# Runnymede Park Improvements

## Phase 1: Exploring Options Public Meeting Summary Report

June 7, 2023

## Design Option 2: Rail Park

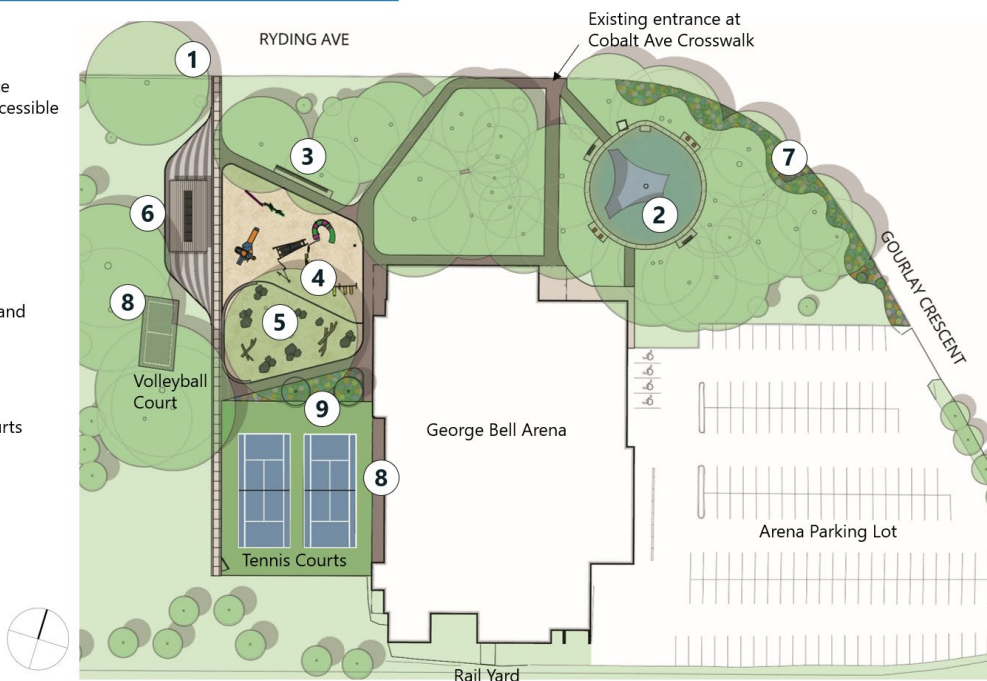
Ensure the pathways create a smooth and nice flow throughout the playground.

Ensure the Rail Park design properly honours the community's rail history.

Consider adding a low fence around the play area to improve safety from dogs.

Maintain an open design for the play area.

Consider adding more communal seating areas.

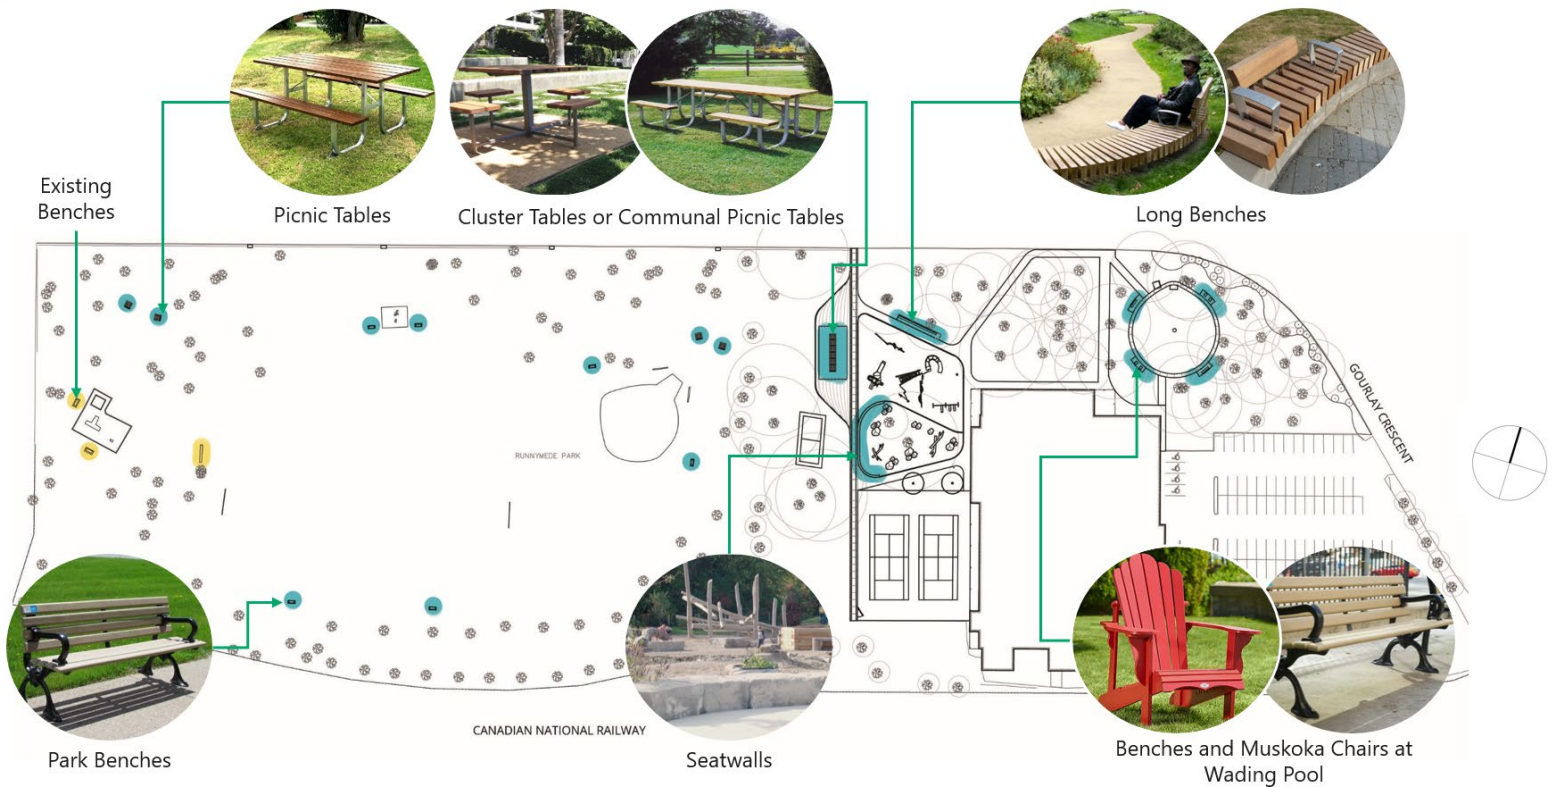
Ensure play structures/area are open and safe

Embrace the rail theme as a way to honour the community's history

Consider replacing rope play with monkey bars and rock climbing

Encourage social gathering by adding more communal seating areas
